Access Compliance Report

Public Rights-of-Way

(Curb Ramps)

Intersection ID: 3596	Main Street: DARBYSHIRE_PL	Cross Street: TREYBURN_DR	Location: NW
ADA ID: 7681DA0971C3	Ramp Type: Perp	Initial Pass/Fail: Fail	Overall Compliance: No
Severity Score: 12.5			
Codes/Mitigation Info/Possible Solution		Field Measurements/Component Compliance

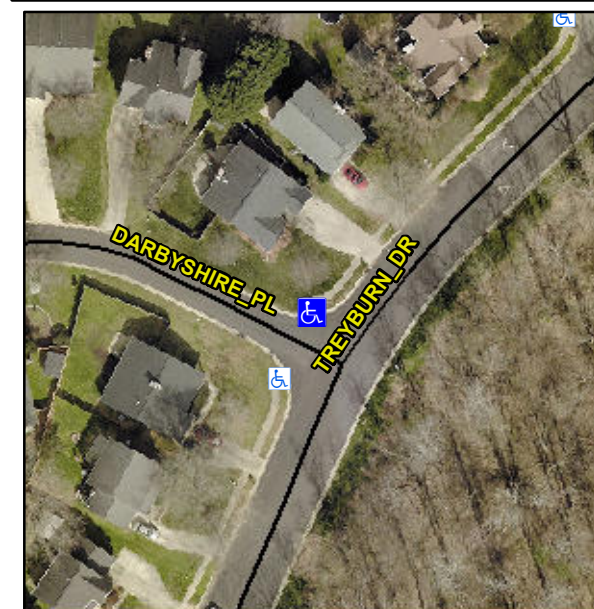
Not Found, R304.2.2

Compliance	Description	Data	Compliance	Description	Data
N/A	Ramp Length (in)	48.0	No	Ramp Slope (%)	9.3
Yes	Ramp Width (in)	48.0	Yes	Ramp XSlope (%)	0.7
N/A	Flare Type LT	N/A	N/A	Flare Type RT	N/A
N/A	Flare Slope LT (%)	N/A	N/A	Flare Slope RT (%)	N/A
N/A	Flare Traversable LT?	N/A	N/A	Flare Traversable RT?	N/A
N/A	Landing Length (in)	N/A	N/A	DWS Provided?	N/A
N/A	Landing Width (in)	N/A	N/A	DWS Contrast?	N/A
N/A	Landing Slope (%)	N/A	N/A	DWS Length (in)	N/A
N/A	Landing X Slope (%)	N/A	N/A	DWS Full Width?	N/A
N/A	Landing Curb? (Y/N)	N/A	N/A	DWS Offset (in)	N/A
N/A	Shared Landing?	N/A			
N/A	Gutter Ponding?	N/A	N/A	Gutter Slope (%)	N/A
N/A	Gutter Lip Ht (in)	N/A	N/A	Gutter X Slope (%)	N/A
N/A	Painted X Walk1?	No	N/A	Painted X Walk2?	N/A
	X Walk 1 Direction	To SW		X Walk 2 Direction	N/A
N/A	X Walk 1 Width (in)	N/A	N/A	X Walk 2 Width (in)	N/A
	X Walk 1 Slope (%)	0.6		X Walk 2 Slope (%)	N/A
	X Walk 1 X Slope (%)	2.0		X Walk 2 X Slope (%)	N/A

Remove & Replace Entire Ramp.
